PLANNING COMMISSION MEETING

LOCATION: TOWNSHIP ANNEX, 7527 HIGHLAND ROAD, WHITE LAKE, MI 48383
THURSDAY, APRIL 17, 2025 – 6:30 PM

RE: White Lake Motors - Preliminary Site Plan Review, Final Site Plan and Final Engineering Review- 3rd Review

Combined Preliminary – Final Site Plan / Special Land Use Review for White Lake Charter Township, Michigan

PROJECT NUMBER: 763515
SCALE: AS SHOWN
DRAWN BY: PT
CHECKED BY: MT/KC
DATE: 12/18/2024
ISSUE: PERMIT
SHEET: OGP IMPROVEMENT PLAN
OGP-2.0

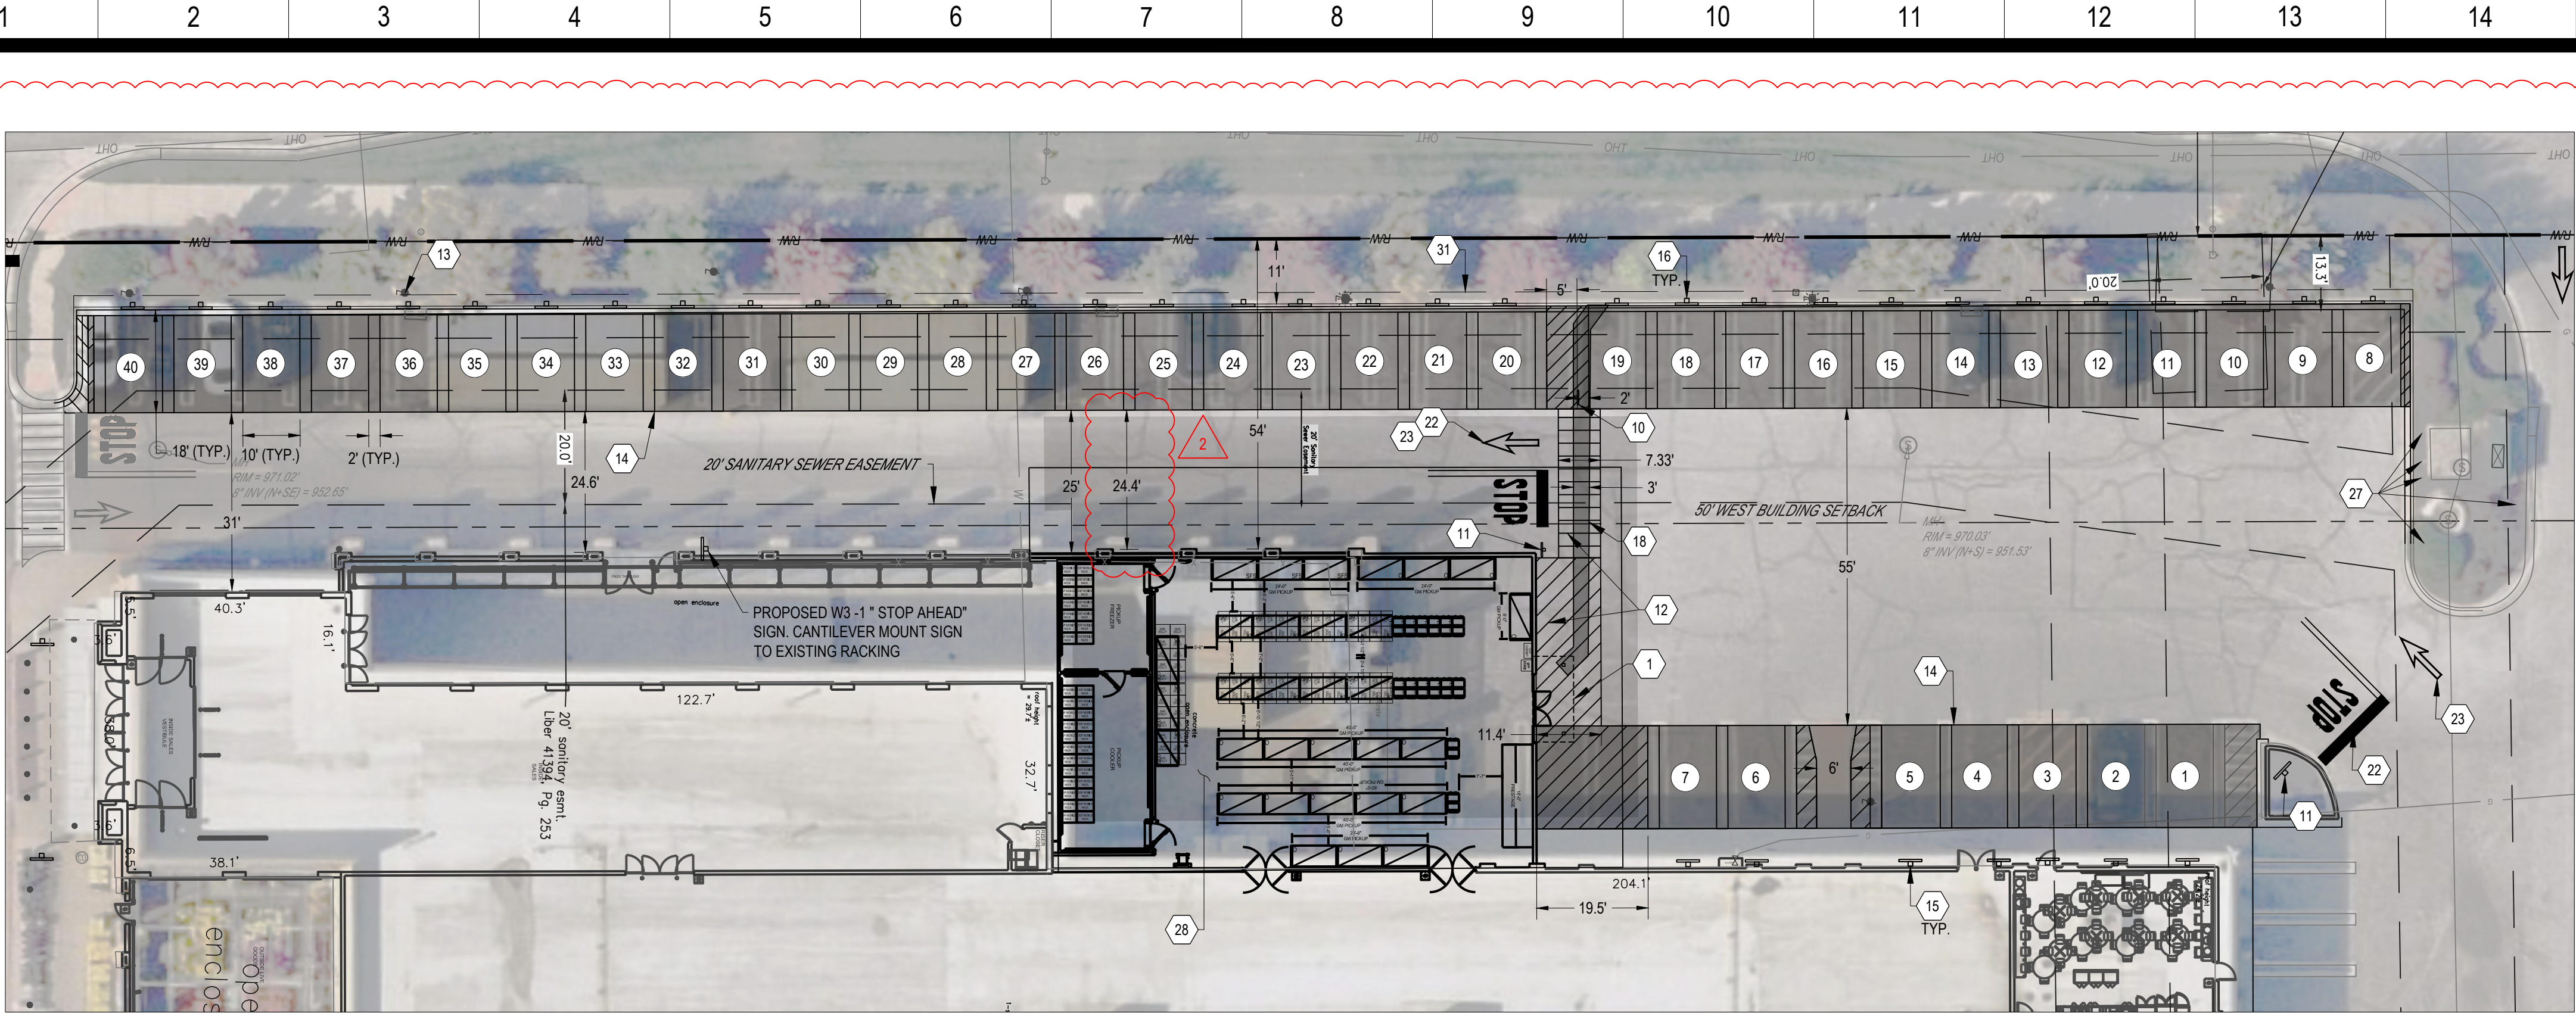
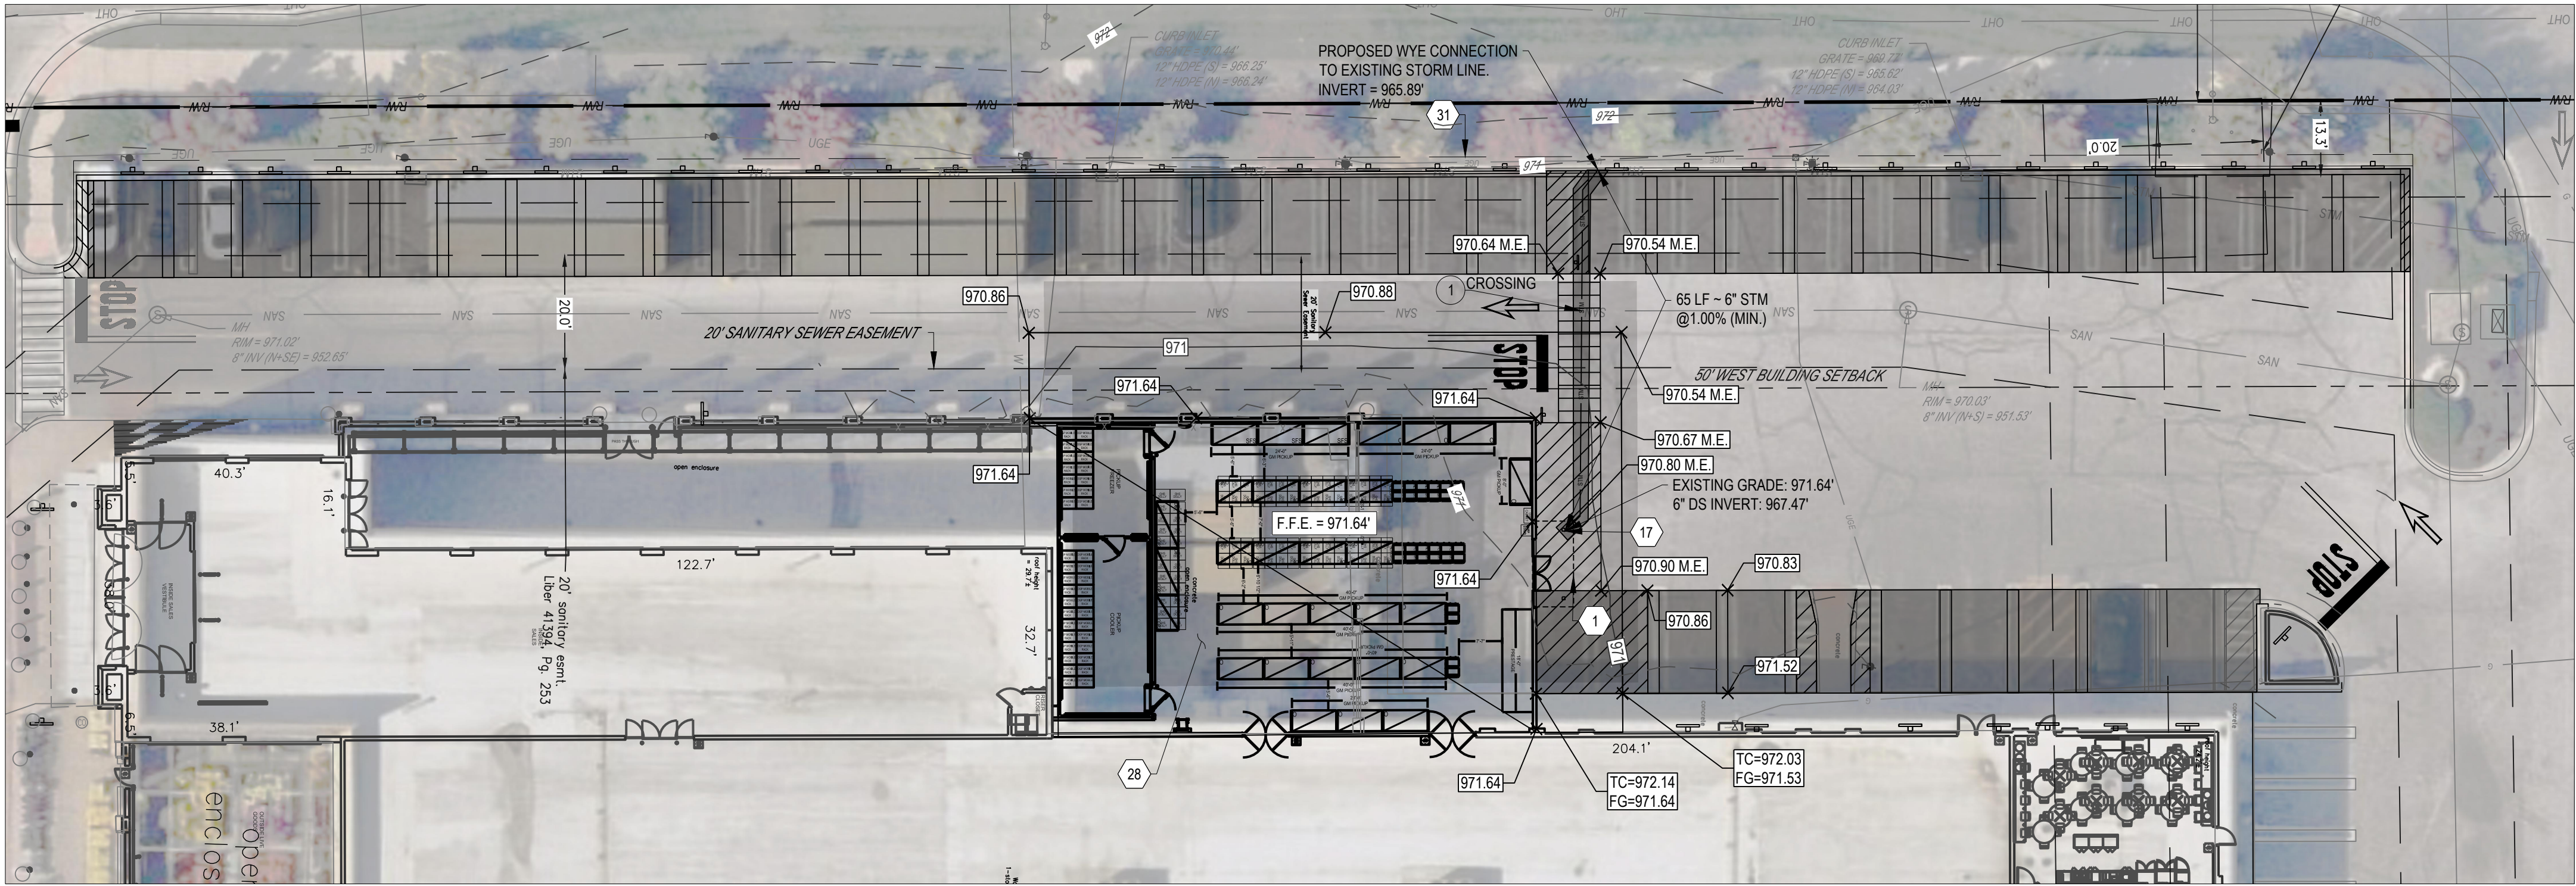
1. *Sheet OGP-2- Coded Notes- Note 18- Provide pipe material proposed for the 6" downspout pipe that is proposed under the pavement. Comment partially addressed. Downspout material is noted in Note 18 on Sheets OGP-2.0 and 2.1; however, material shall conform to that listed on WLT Storm Sewer Details sheet.* **Comment addressed. Note has been updated to reference WLT storm sewer details sheet for allowable pipe material.**

3. *Sheet OGP-2- Provide TP and BP elevations at proposed storm/sanitary crossing. We note an 18" vertical separation is required between the two utilities.* **Comment addressed. Information has been provided.**

4. *Sheet OGP-2.1-Show proposed invert elevations at proposed wye connection to storm sewer.* **Comment addressed. Proposed invert elevation is now shown.**

5. *Sheets OGP2.0 and 2.1-Note 18. Note refers to connection of proposed downspout into existing storm structure. Current plan proposes connection of proposed downspout to existing storm sewer via a wye connection. Please revise this note on all relevant plan sheets.* **Comment addressed. Wording has been updated.**

SHEET: C1

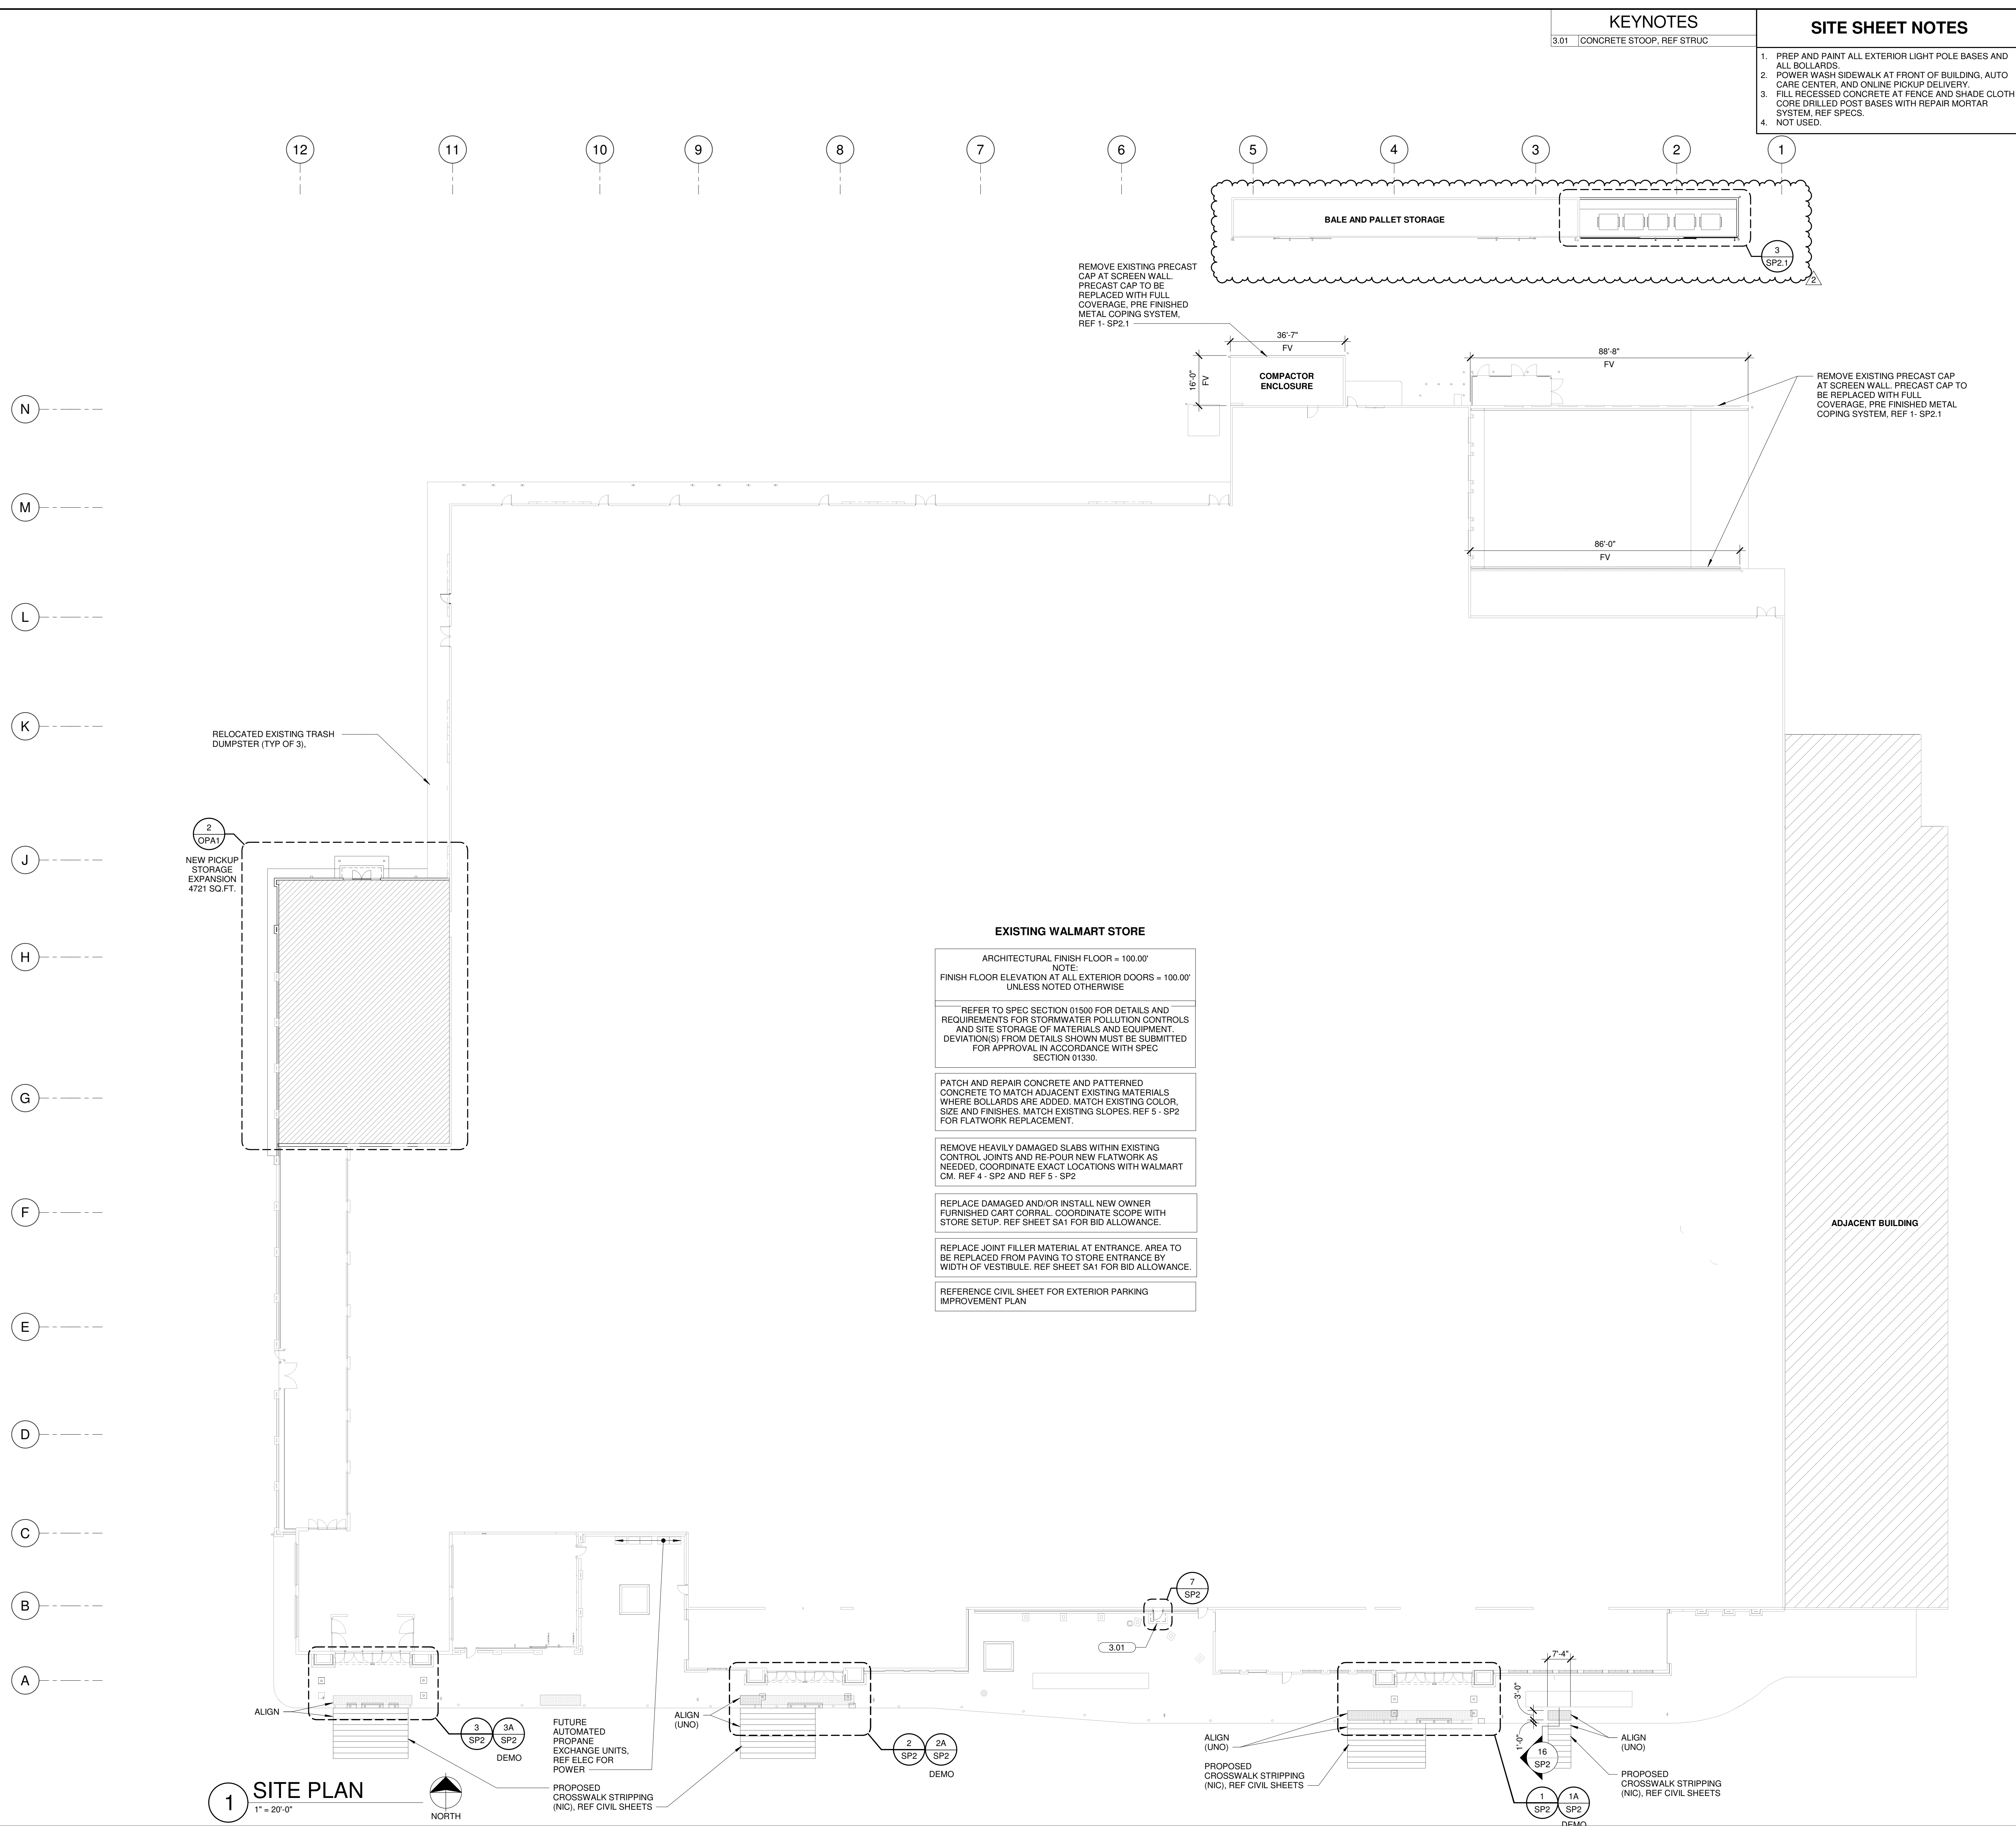
- a. Sheet C1- Bottom of sheet- Update Planning & Zoning Review from Justin Quagliata to Andrew Littman.
 - b. Sheet SP1- Correct spelling of 'stripping' to 'striping' for all misspelled areas on this sheet.

- c. Sheet SP1- Remove 'Relocated Existing Trash Dumpster (Typ of 3)' note on west side of building.
 - d. Sheet SP2.1- 3 Organic Waste Screening Plan- remove note 'Note: Ref Civil for location.' Location of dumpsters is shown on architectural plan Sheet C1 and not on the civil plan sheets.
